STATE OF VERMONT AGENCY OF TRANSPORTATION

PROPOSED IMPROVEMENT BRIDGE PROJECT TOWN OF BRIDPORT COUNTY OF ADDISON VT ROUTE 125 (MAJOR COLLECTOR) BRIDGE NUMBERS 2 AND 5

PRE-CONTRACT PLANS
5/16/2014

DIRECTOR OF PROGRAM DEVELOPMENT	
APPROVED _____	DATE _____
PROJECT MANAGER : MARK SARGENT, P. E.	
PROJECT NAME : BRIDPORT	
PROJECT NUMBER : STP CULV (29)	
SHEET 1 OF 53 SHEETS

PROJECT NAME: BRIDPORT  
 PROJECT NUMBER: STP CULV(29)  
 FILE NAME: zllc264bdr_impacts_br2.l.dgn PLOT DATE: 5/16/2014  
 PROJECT LEADER: M. CHENETTE DRAWN BY: L. BUXTON  
 DESIGNED BY: J. HUNGERFORD CHECKED BY: M. CHENETTE  
 PROJECT IMPACTS PLAN I - BR2 SHEET 31 OF 53

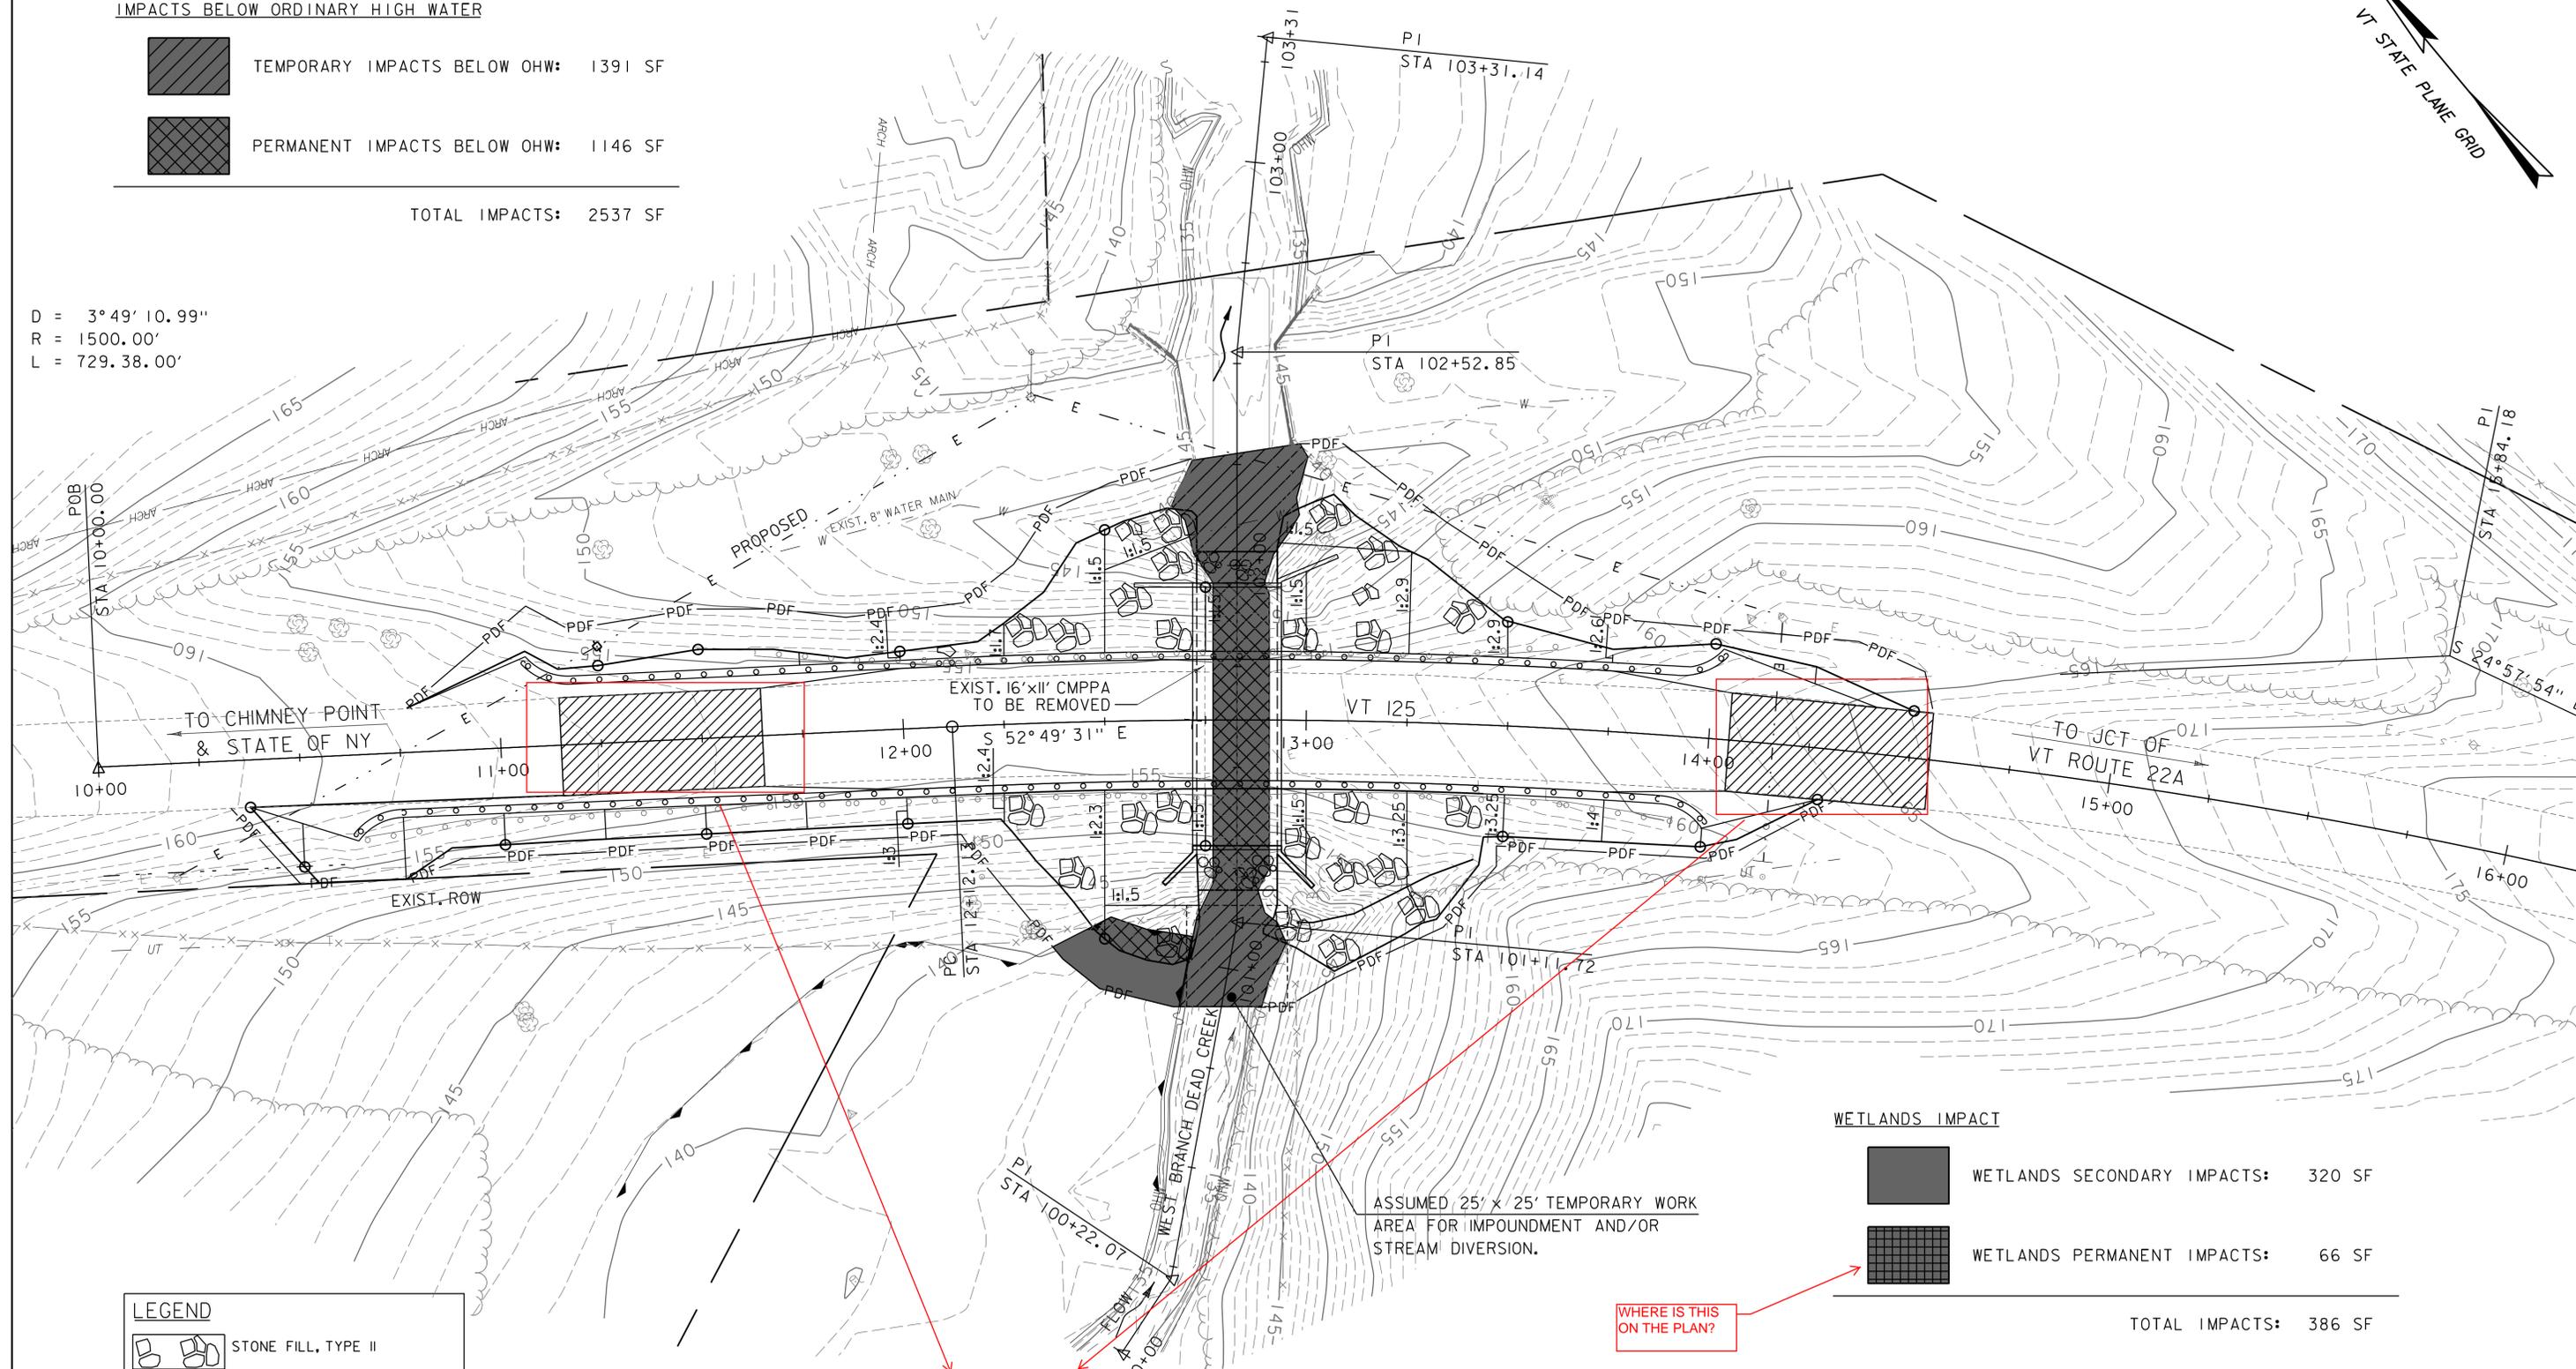
LABEL COLD PLANING

WHERE IS THIS ON THE PLAN?

PROJECT NAME:	BRIDPORT
PROJECT NUMBER:	STP CULV(29)
FILE NAME:	zllc264bdr_br5.dgn
PROJECT LEADER:	M. CHENETTE
DESIGNED BY:	J. HUNGERFORD
PLAN LAYOUT SHEET -	BR5
PLOT DATE:	5/16/2014
DRAWN BY:	L. BUXTON
CHECKED BY:	M. CHENETTE
SHEET	35 OF 53

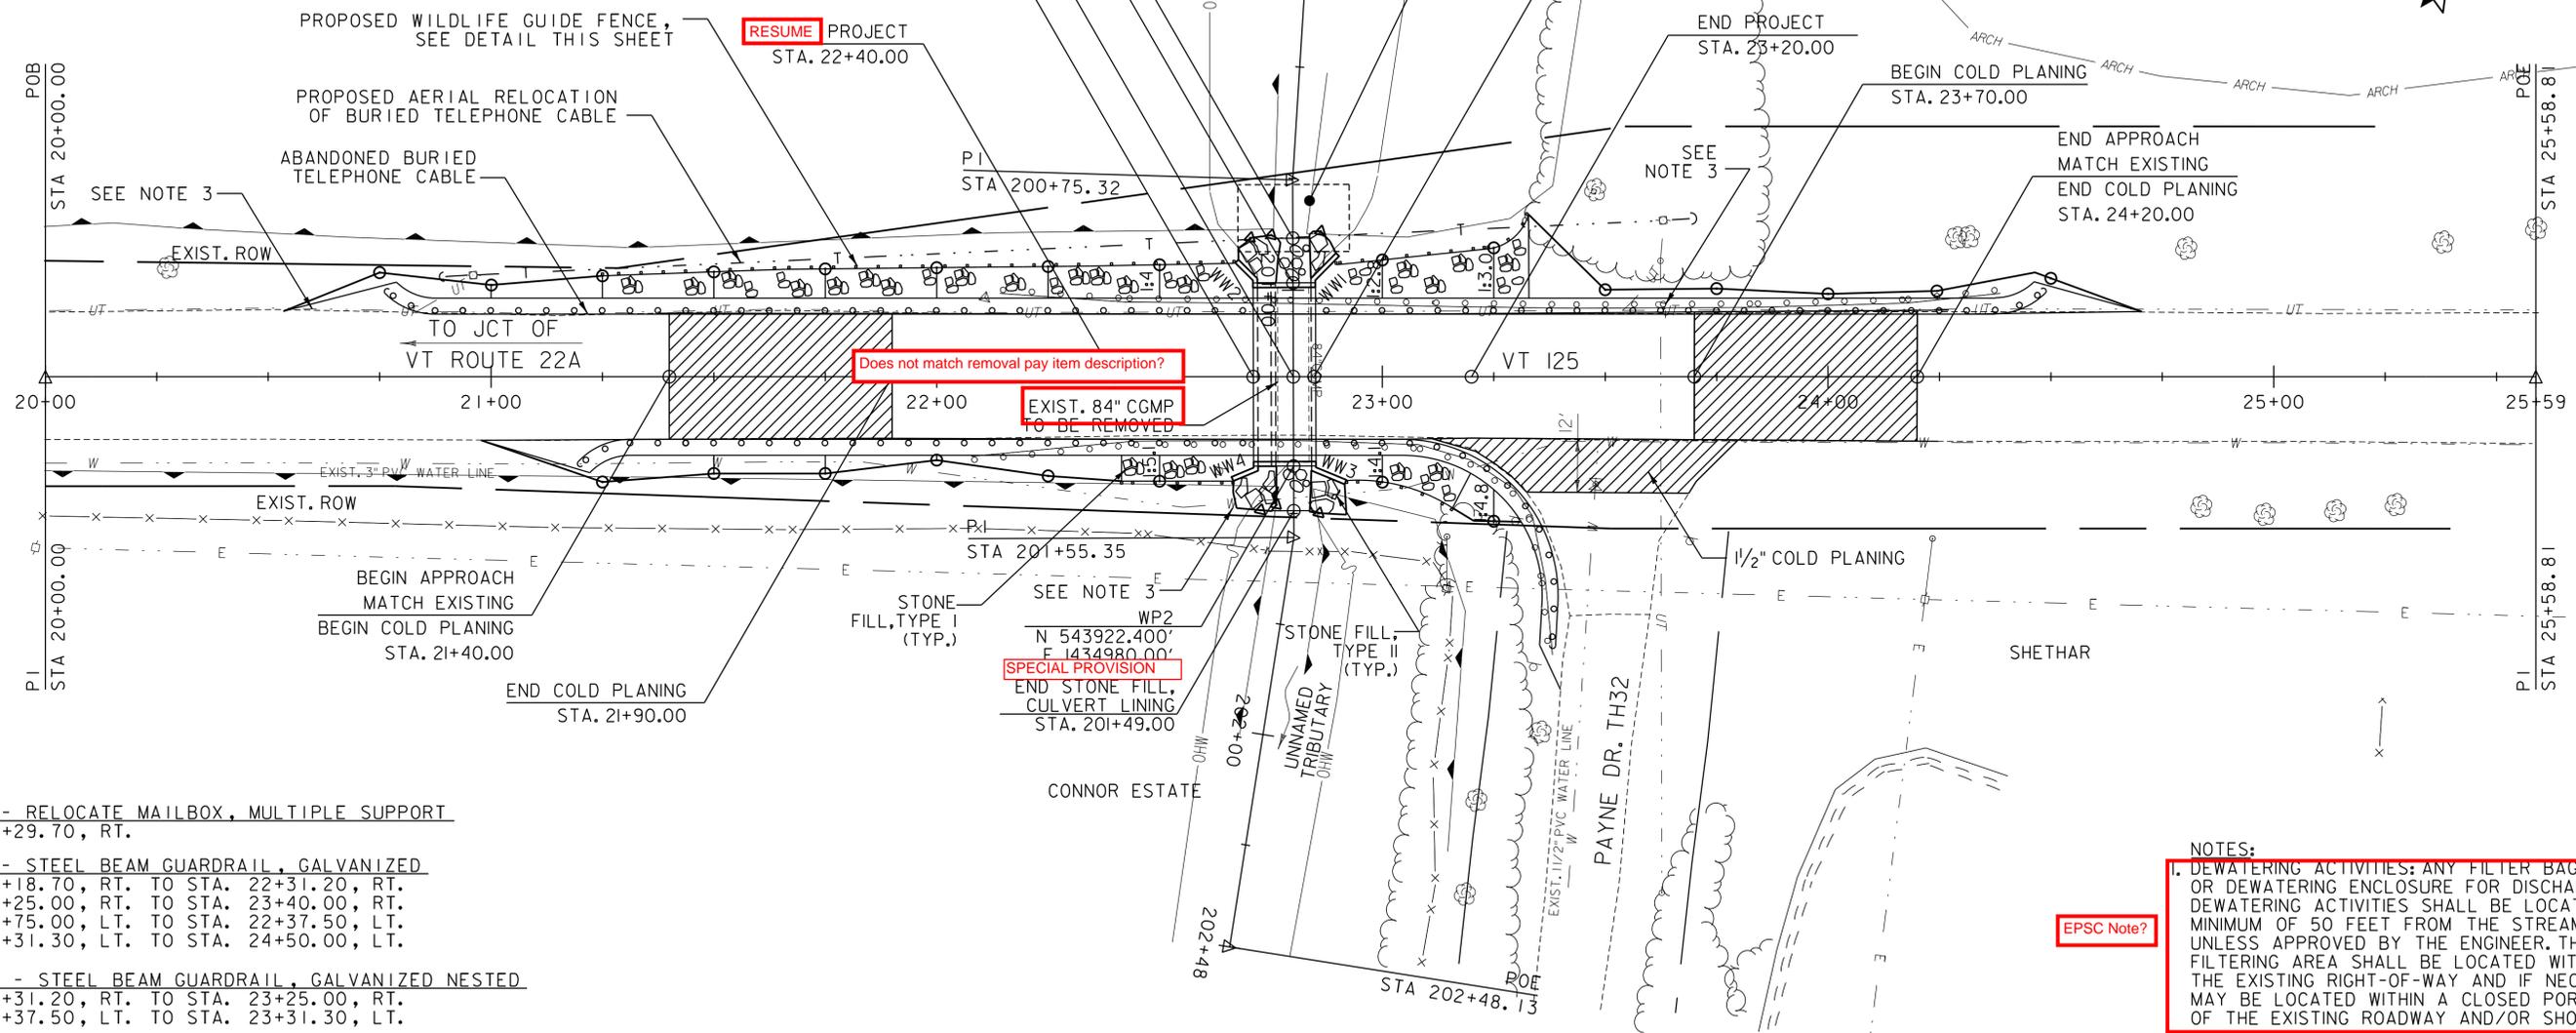
Does not match removal pay item description?  
EXIST. 84" CGMP  
TO BE REMOVED

ADD THESE TWO ITEMS TO  
THE QUANTITY SHEET?  
PLEASE VERIFY - PAINT  
ITEMS ENTERED ON  
QUANTITY SHEET.

PROJECT NAME:	BRIDPORT	PLOT DATE:	5/16/2014
PROJECT NUMBER:	STP CULV(29)	DRAWN BY:	L. BUXTON
FILE NAME:	zllc264strpl_br5.dgn	DESIGNED BY:	J. HUNGERFORD
PROJECT LEADER:	M. CHENETTE	CHECKED BY:	M. CHENETTE
STRUCTURAL PLAN AND DETAILS - BR5		SHEET	38 OF 53

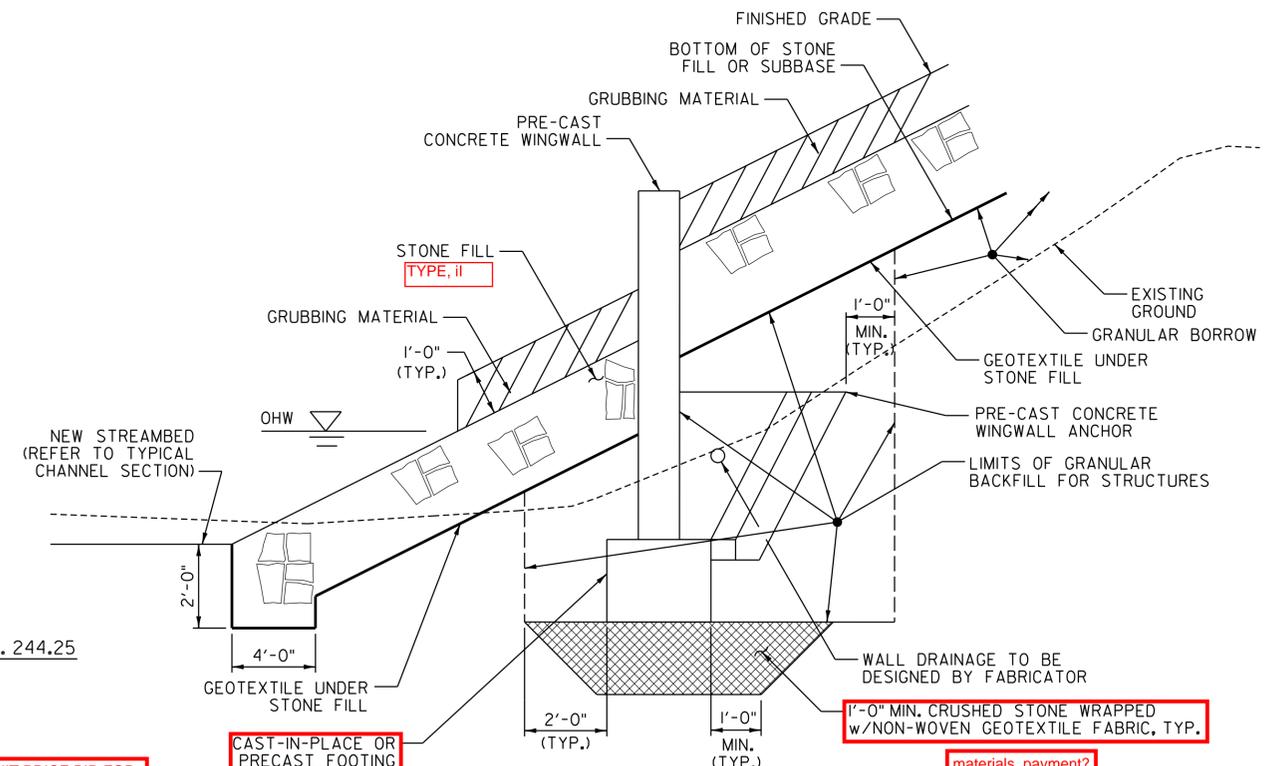
Option not mentioned in precast concrete notes on Sheet 4?

Should be on Sheet 8.

PROJECT NAME:	BRIDPORT	PLOT DATE:	5/16/2014
PROJECT NUMBER:	STP CULV(29)	DRAWN BY:	I. MAYNARD
FILE NAME:	zllc264tcdet_br5_l.dgn	CHECKED BY:	J. HUNGERFORD
PROJECT LEADER:	M. CHENETTE	SHEET	40 OF 53
DESIGNED BY:	I. MAYNARD		
TRAFFIC CONTROL DETAILS I - BR5

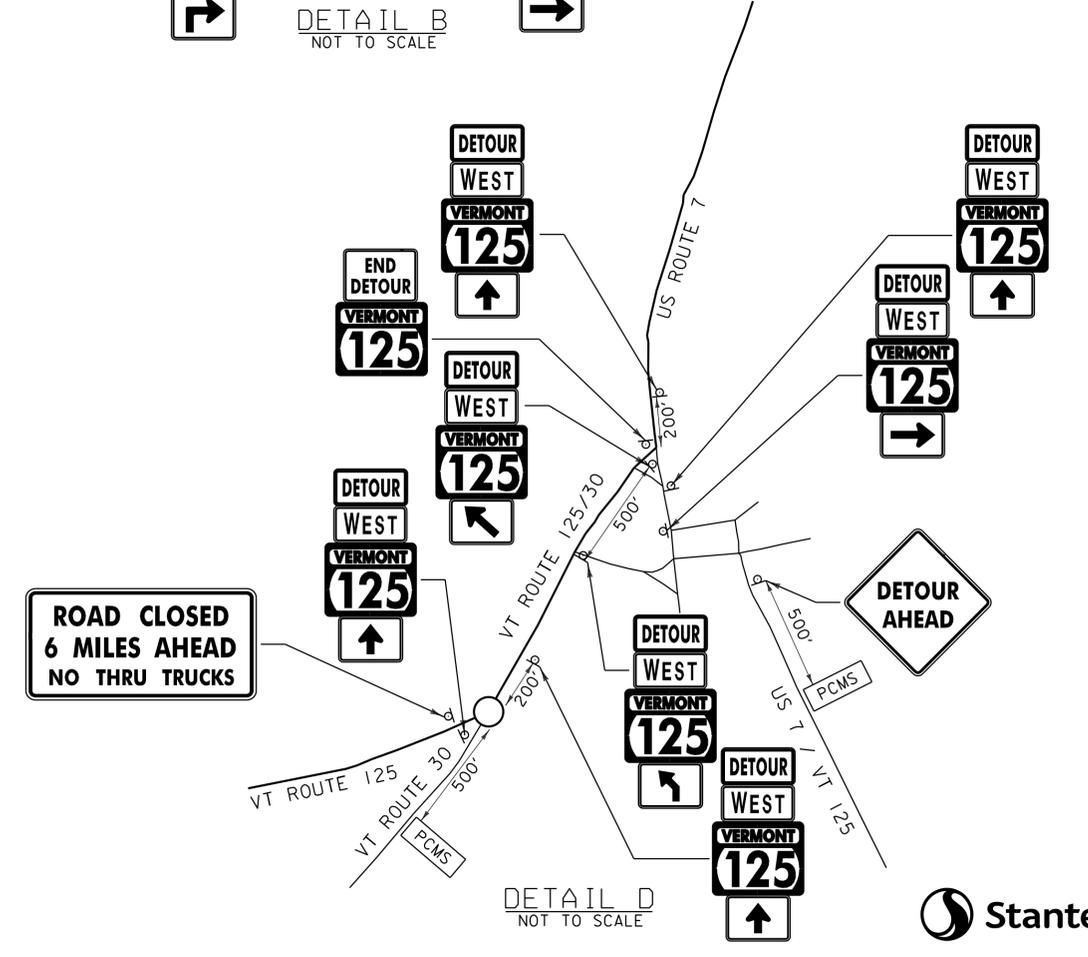
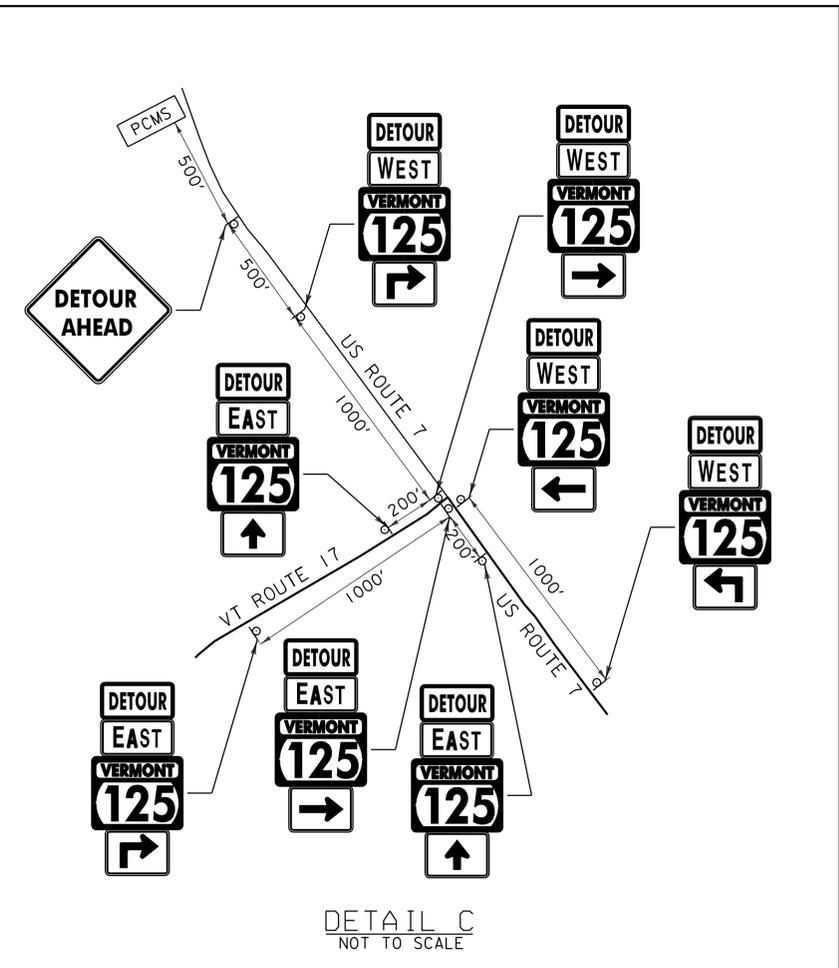
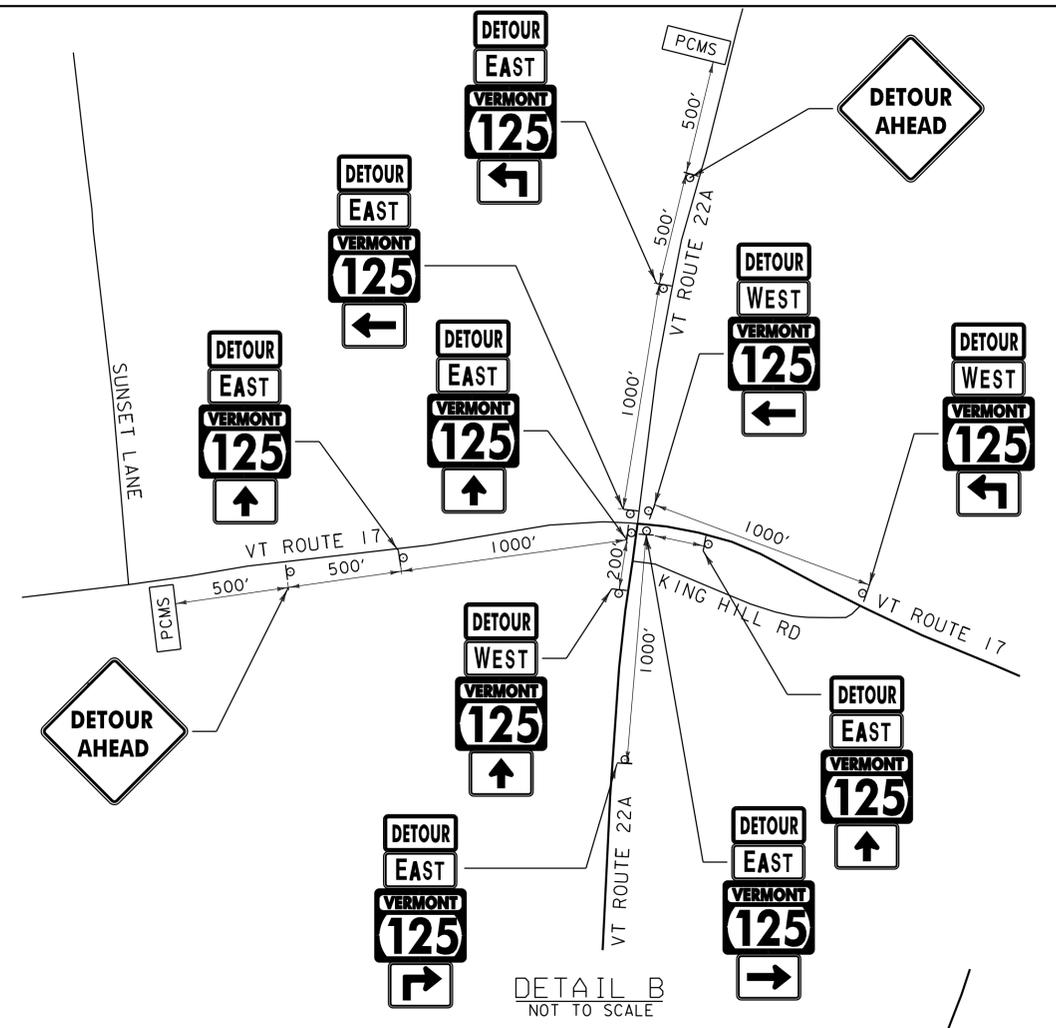
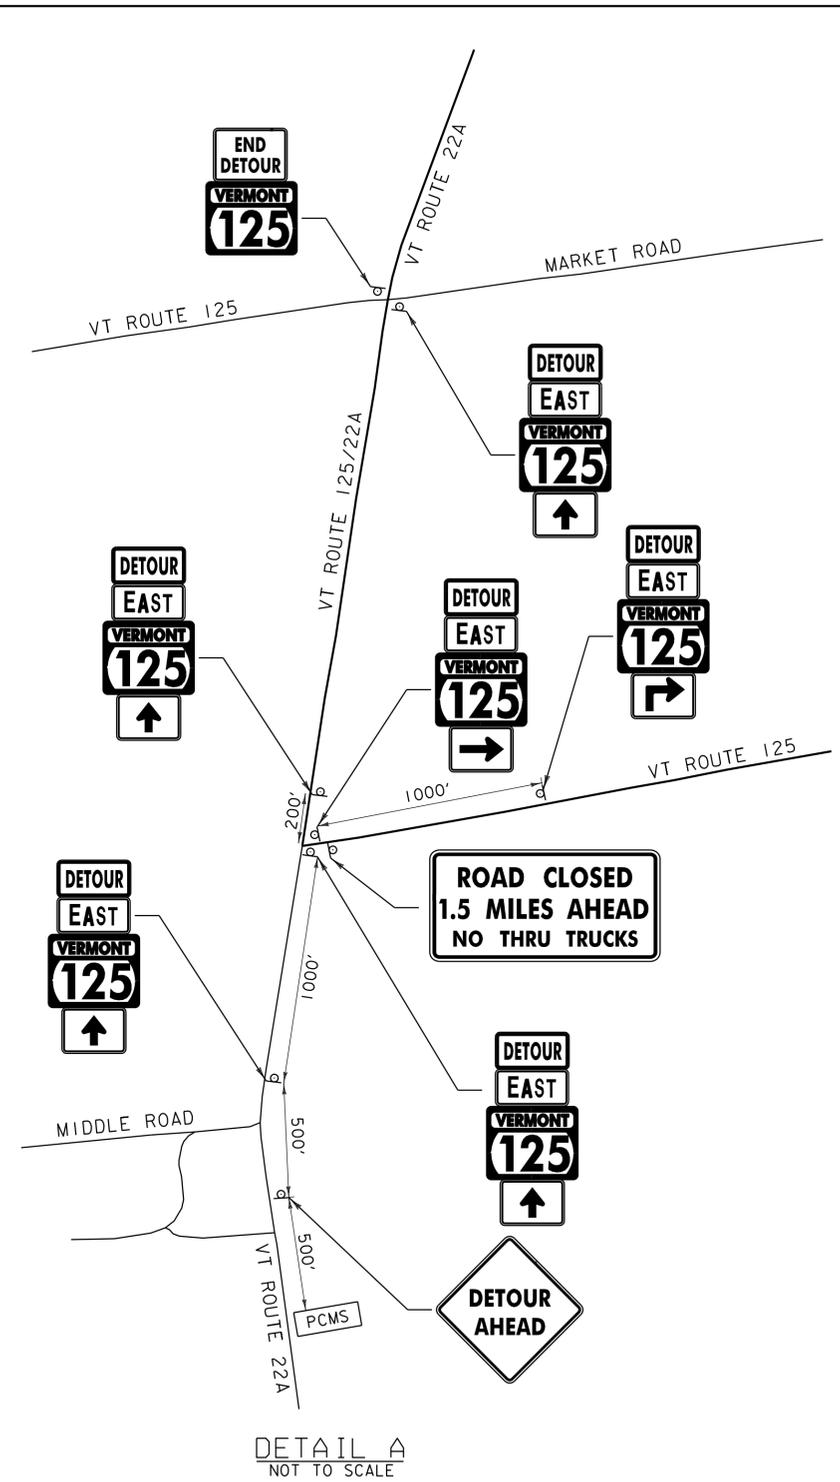
PCMS = PORTABLE CHANGEABLE MESSAGE SIGN Not used here; more appropriate for Sheet 40.
